State of Washington
DEPARTMENT OF FISH AND WILDLIFE

June 21, 2011

SUBJECT: Washington Department of Fish and Wildlife Shoreline Exemption L10SX040, Tokul Hatchery Emergency Repairs and Mitigation

Figure 1: Cross section of Tokul Ck at the location of the proposed log jam. Not to scale.

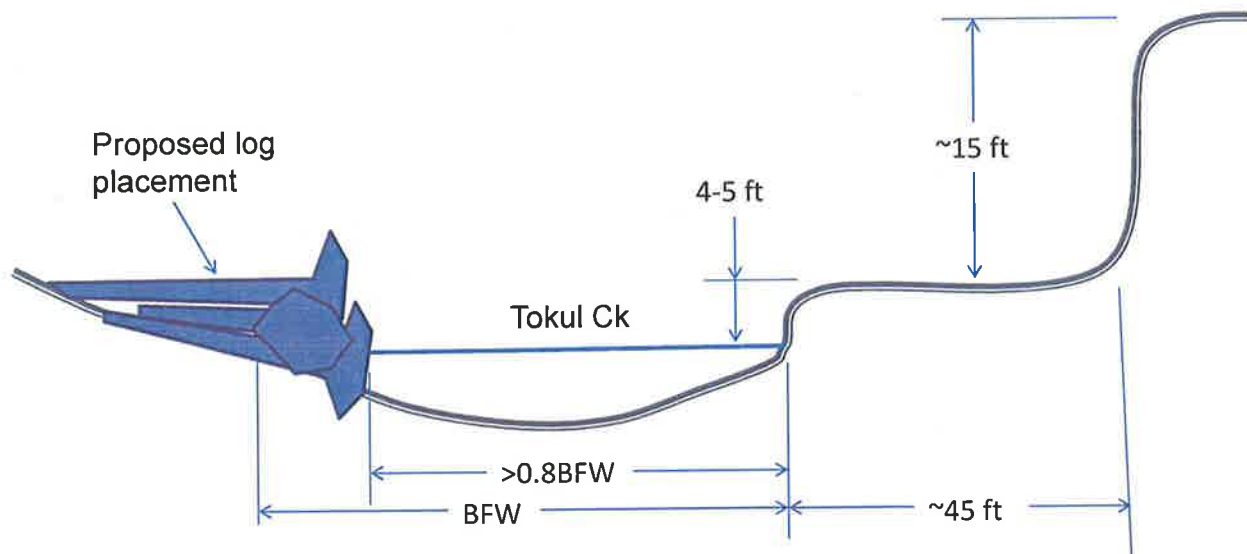
This project is located on a reach of Tokul Creek that experiences landslides on the south side of the Creek. A couple of the tri-groin structures are proposed opposite recent landslides and in narrow portions of the stream. Please have your engineering geologist or fluvial hydrogeomorphologist respond with an evaluation of the risk of future landsliding due to installation of these tri-groin structures.

We have now changed the location of these structures from what was originally proposed and reduced the number from 3 to one. Please see the revised drawings in this package for their new location. By moving what has now become a small log jam, we have substantially reduced the threat of landslide for two reasons.

1. The channel at this location is much less confined. The entrenchment ratio in the upstream reach is probably less than 2 with typically deep flow and high velocity during storm events. Confined channels are prone to bed or bank erosion because of this and structures that further confine flow can exacerbate the effect. The entrenchment ratio at the new site is likely in excess of 3 with lower hydraulic stress. I do not believe that adding wood to this reach, in the way that we propose, will cause channel wide scour.

2. Rather than the steep high bank common in the upstream reach, there is a 15 foot high terrace behind a 45 ft wide floodplain. Please see Figure 1. Should there be any left bank erosion, it would move into the low bank flood plain area and not at the toe of a steep slope. In the unlikely event that substantial lateral erosion occurred and it did reach the toe of the terrace, there would not be the massive response that occurred at the DOT site.

I have suggested to our design staff that the log structure should not penetrate more than 20% into the bankfull channel. Various researchers (Young 1991; Gippel, O'Neill et al. 1996; Dudley, Fischenich et al. 1998) have found that when wood structures block less than about 15-20% of the bankfull with, there is minimal channel backwater and the channel wide effects that that causes.
